GEK-65675
Insert Booklet GEK-45346

AUTOMATIC RECLOSING RELAY

TYPE NSR

MODEL 12NSR99AB001A

Fig. 1 (0285A5796-0) Internal Connections for the 12NSR99AB001A Relay

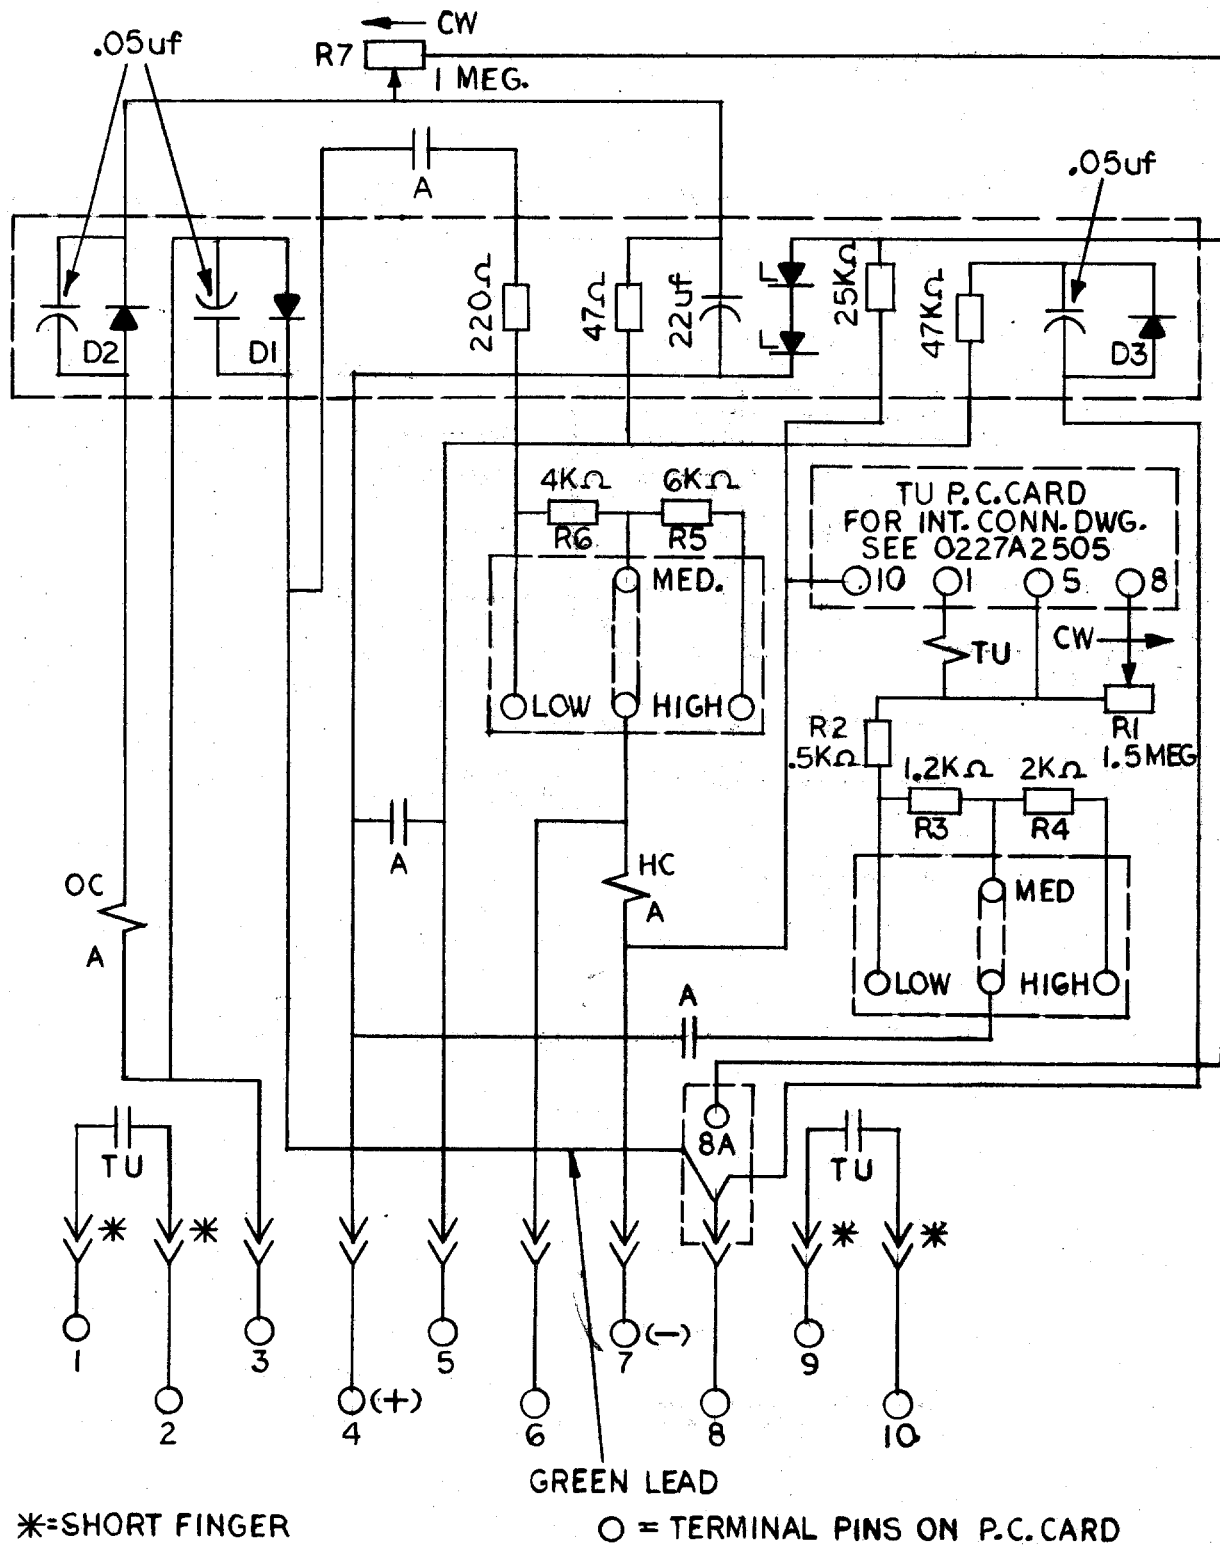
The 12NSR99AB001A relay is similar to the 12NSR21G1A relay except the normally open "A" contact between terminals 9 and 10 is replaced by a normally open "TU" contact. See Fig. 1 of this book.
